PROJECT TITLE: SOAS INTO SENATE HOUSE MALET STREET LONDON, WC1E 7HU

DRAWING TITLE: LEVEL 1 DOOR/WINDOW/PARTITION KEY PLAN

PROJECT NO.	28731	DRAWN BY	DC	DATE	25/07/13
CHECK BY	LT	DATE	25/07/13		
APP'D BY	-	DATE	25/07/13		
PROJECT CODE	DISC	VIEW TYPE	VIEW CAT	LEVEL	DWG NO.
SOAS - A - PLN - GEN - 01 - 293					
SHEET NO.	1 of 1	SCALE	As indicated	ORIG. SHEET SIZE	REV.
			@ A1	C	3

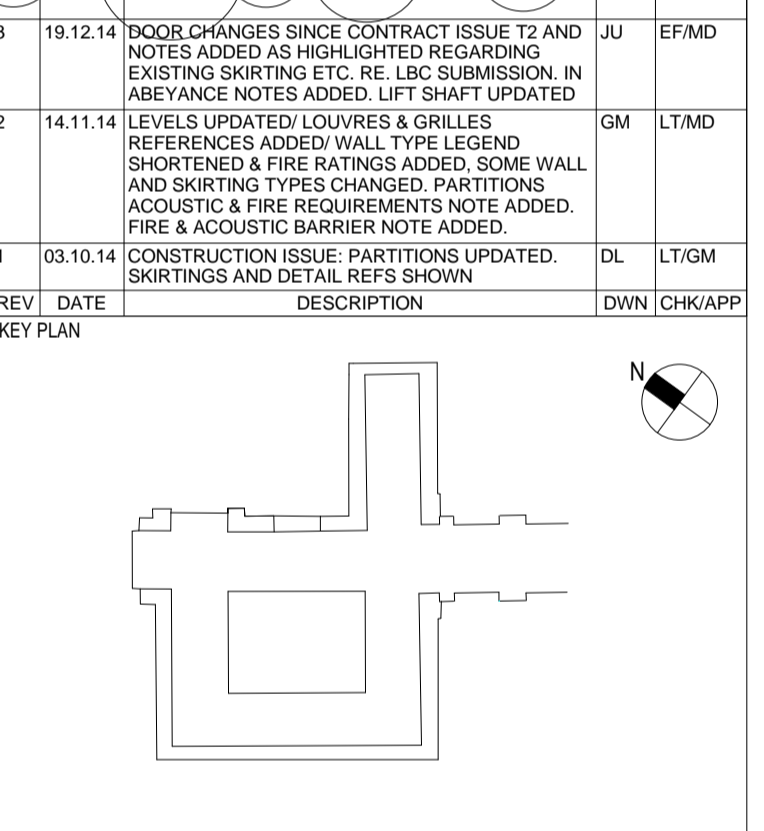
CHANGES BETWEEN T2 AND C3:
 1 - NEW DOOR 120MIN FR ADD TO LOCATION: 1.61A, 1.54A. 2 - NEW DOOR 120MIN FR CHANGE LOCATION AND SIZE, IN LOCATION: 1.12A.
 3 - 120MIN FR DOOR CHANGE FROM SINGLE LEAF TO DOUBLE IN LOCATION: 1.59A.
